EMA/CHMP/50784/2022
Human Medicines Division

Type IB variation report

COMIRNATY	EMA/H/C/005735/IB/0106/G
INN / Common name	tozinameran
Scope as per guideline	<p>B.I.b.1.c - Change in the specification parameters and/or limits of an AS, starting material/intermediate/reagent - Addition of a new specification parameter to the specification with its corresponding test method</p> <p>B.I.b.2.c - Change in test procedure for AS or starting material/reagent/intermediate - Other changes to a test procedure for a reagent, which does not have a significant effect on the overall quality of the AS</p>
Precise scope	<p>B.I.b.1.c (IB) - To add Activity test method acceptance criteria to the specifications of active substance raw materials listed below, used in the manufacturing process of the active substance Tozinameran at Pfizer, Andover. The limits have been set as follows:</p> <ul style="list-style-type: none">- DNase I: [REDACTED]- Proteinase K: [REDACTED]- Pyrophosphatase [REDACTED]- RNase inhibitor: [REDACTED]- T7 polymerase [REDACTED] <p>B.I.b.2.c (IB) - To add the in-house Purity test procedure for the DNase I, Pyrophosphatase, RNase inhibitor and T7 polymerase raw materials used in t

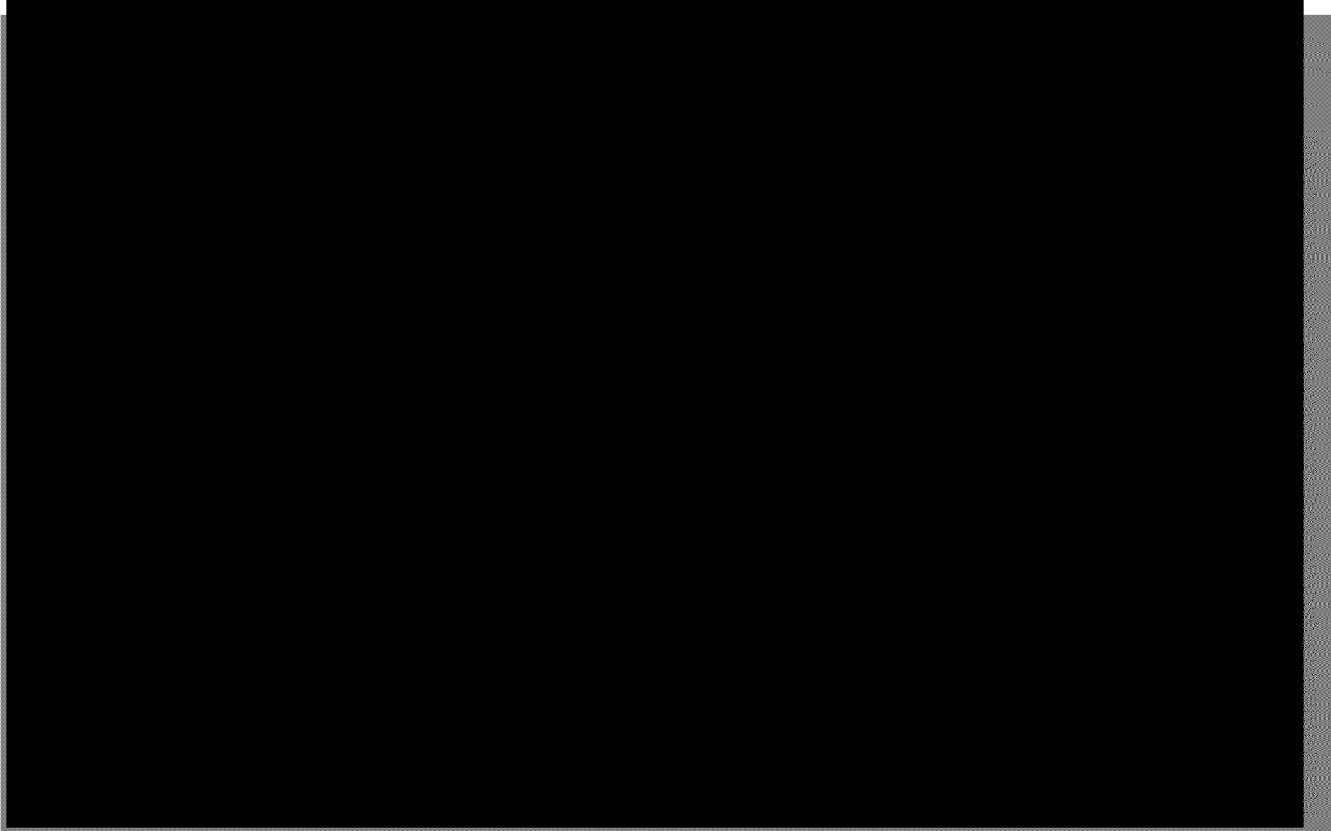
The MAH states that new small-scale studies have been initiated to increase the DNase I robustness. In order to fulfil REC#7, data and conclusions from these studies should be provided. [REDACTED] the correlation between DNase I activity, residual DNA and possibly other parameters should be sufficiently evaluated and discussed.

The Applicant explains that the main conclusion from the small-scale studies and manufacturing experience is that residual DNA levels are affected by [REDACTED]

at all drug substance manufacturing sites to improve [REDACTED]. Additionally, control strategy was enhanced by introducing independent activity testing with defined acceptance criteria for DNase I (and other enzymes). Results from the drug substance manufacturing scale adjustments show consistent residual DNA levels in drug substance. Data from drug substance batches (one manufacturing site) before and after the adjustments are shown in Figure 1.

In order to complete REC #7, data from the two additional sites Mainz/Rentschler and Marburg should be provided. Section 3.2.S.2.5 of the dossier should be updated with data on residual DNA levels from all three sites. In addition, section 3.2.S.2.2 should be updated with information on the enhanced process control. If possible, the minor adjustments should be reflected in the related acceptance criteria.
